Lake Whatcom Water & Sewer District

REGULAR MEETING OF THE BOARD OF COMMISSIONERS

The proposed 2026 edition includes relatively minor revisions since the last edition that was adopted by the board on April 26, 2023. Staff will provide an overview of the revisions during the January 28 meeting and request board consideration of adoption during the meeting.

FIRE HYDRANT ASSEMBLY

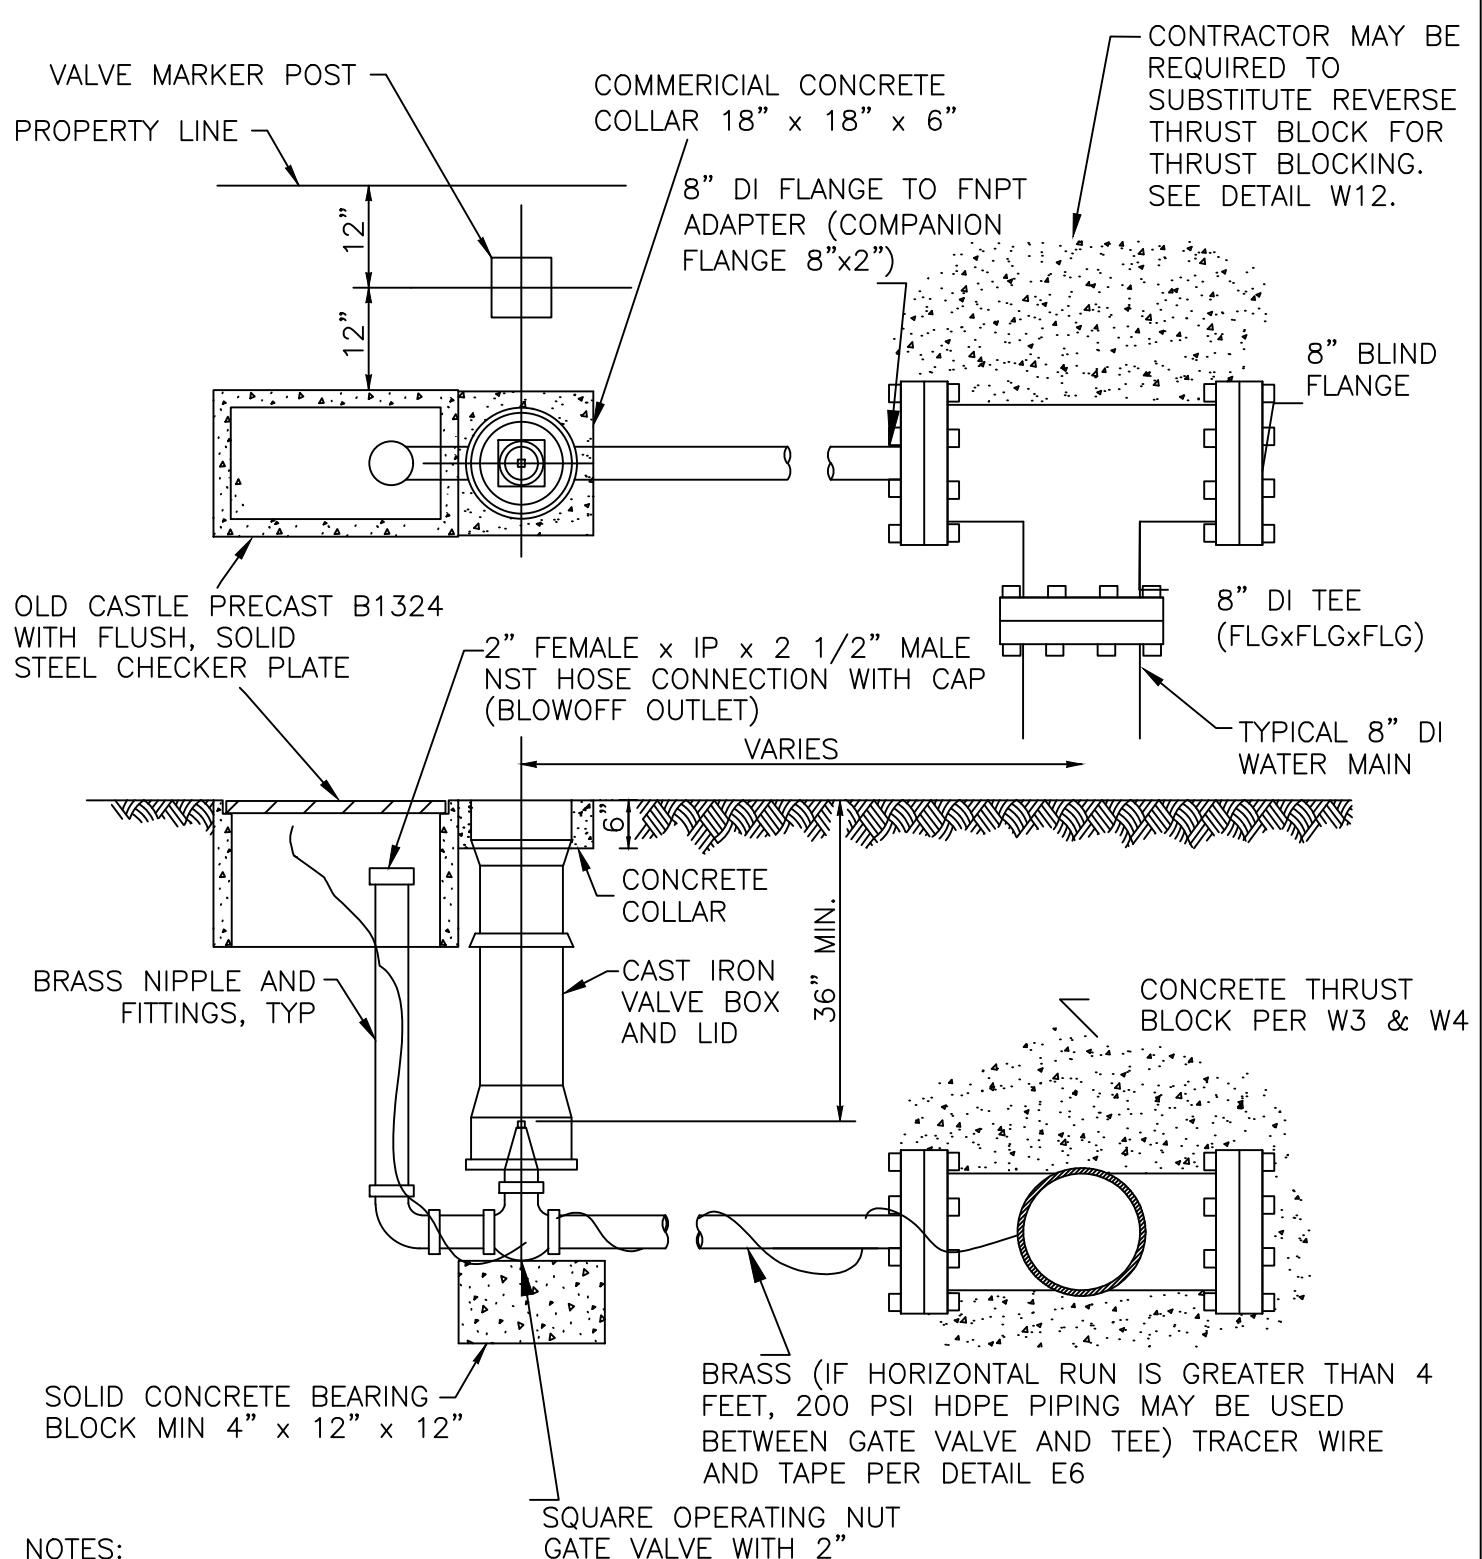
NOTE ADDED.

GRINDER PUMP SERVICE TO GRAVITY MAIN INSTALLATION

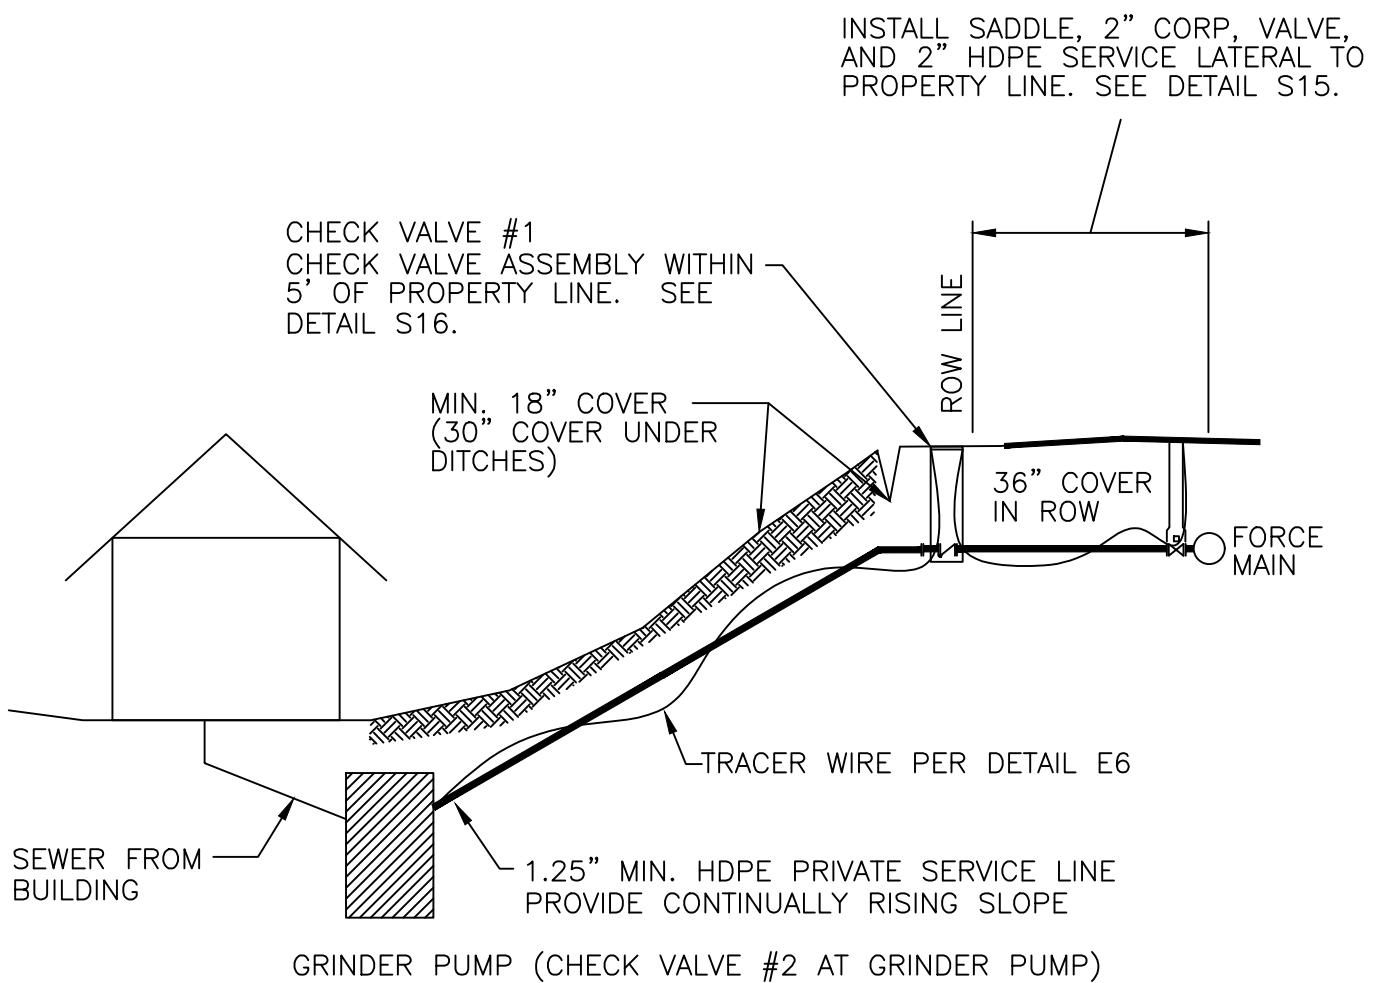
NOTE REVISED TO REFERENCE ECOLOGY MANUAL
FOR GRINDER PUMP COMPONENTS.

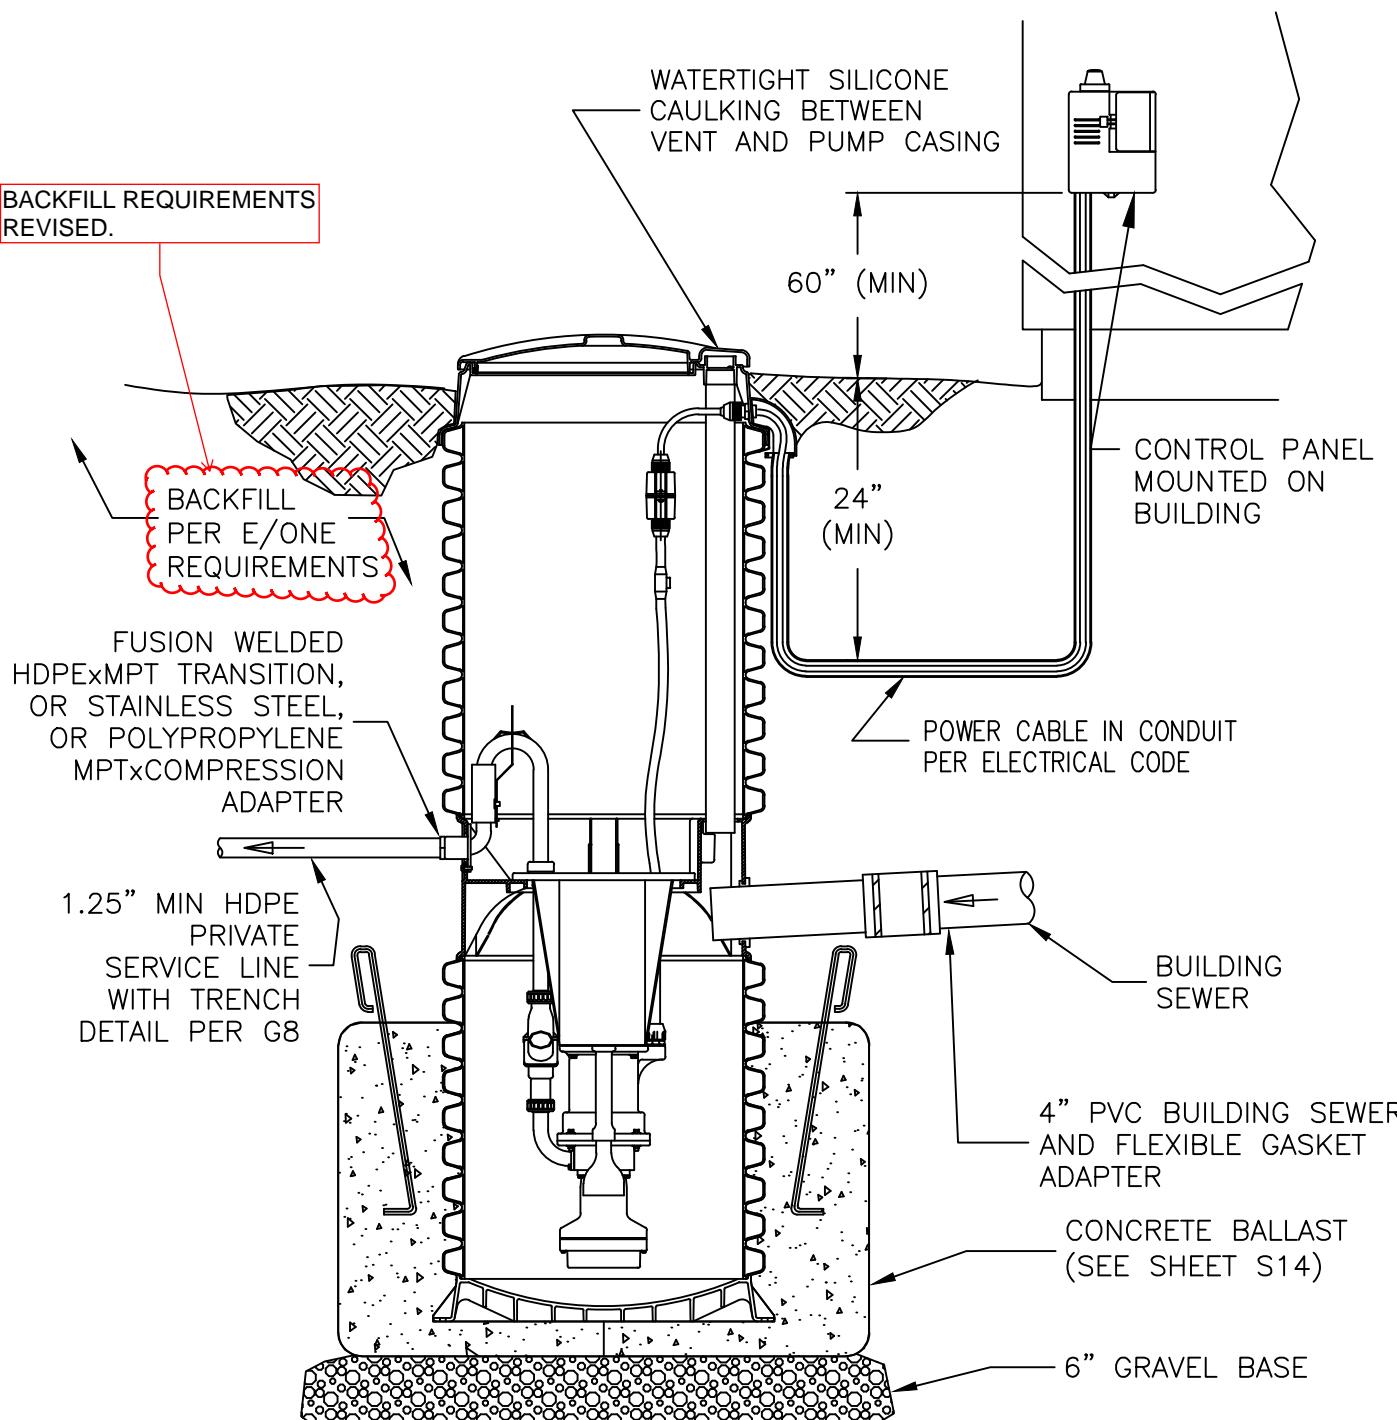
BACKFILL REQUIREMENTS REVISED.
